HISTORIC AND DESIGN REVIEW COMMISSION

March 15, 2017

HDRC CASE NO: 2017-112
ADDRESS: 4715 HOWARD ST
LEGAL DESCRIPTION: NCB 9013 BLK 7 LOT 43 THRU 47
ZONING: R-4
CITY COUNCIL DIST.: 1
DISTRICT: Olmos Park Terrace Historic District
APPLICANT: Joseph Calderoni
OWNER: Joseph Calderoni
TYPE OF WORK: Installation of new driveways
REQUEST:

4715 HOWARD ST. SITE PLAN

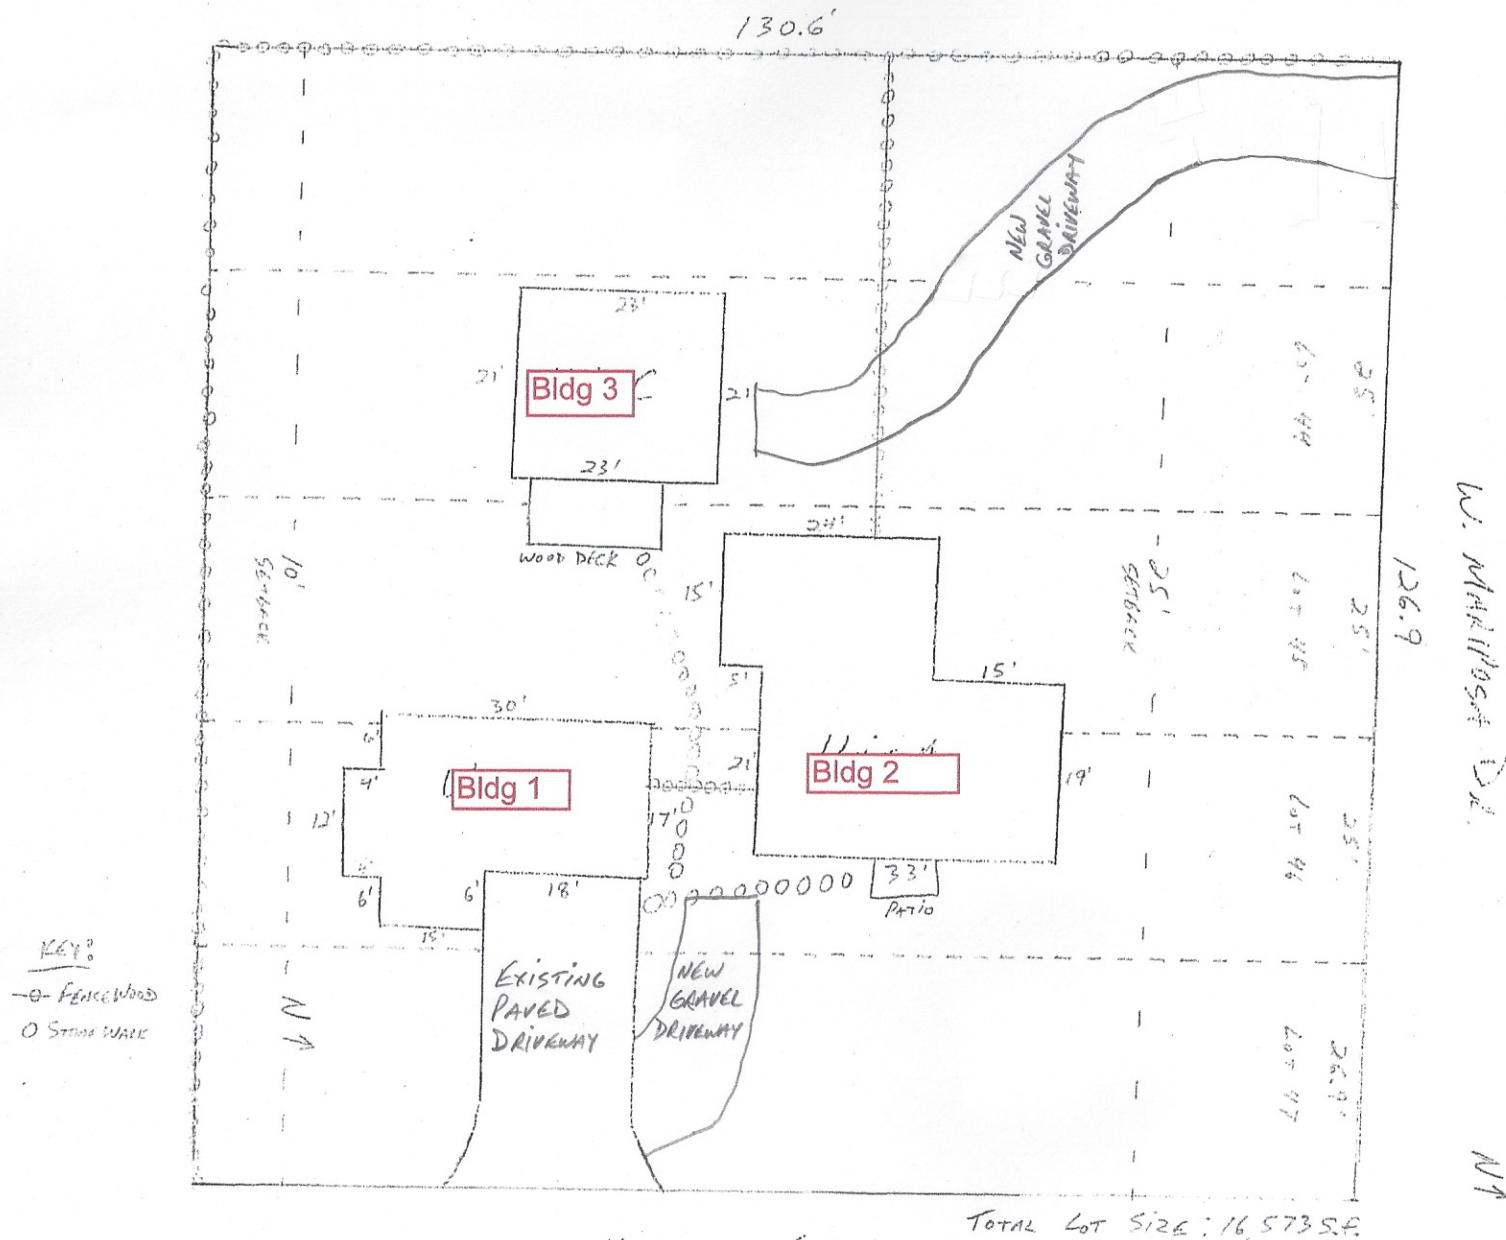
- b. According to the Guidelines for Site Elements, driveway configurations should be historically similar to those found on site in terms of materials, width, and design, and be no wider than 10 feet in width. Driveways of the proposed width are common in the district and staff finds request 1 consistent with these guidelines.

- c. Additionally, concrete approaches are common in the district and an element of almost every property along W Mariposa, where the driveway to the third structure is proposed. Staff finds this proposal acceptable.

- d. Traditionally, primary driveways in the Olmos Park Terrace Historic District are concrete. While staff finds that gravel is a good, non-permanent solution for secondary driveways, paving materials located at the primary entrance should be high quality and feature compatible materials. The addition of pavers or a more permanent, semi-permeable system would be more appropriate for the front driveway.

Staff recommends approval based on findings a through d with the stipulation that the primary driveway off Howard St utilizes alternative paving materials instead of the gravel. A proposal for pavers or a similar material may be submitted to staff for approval.
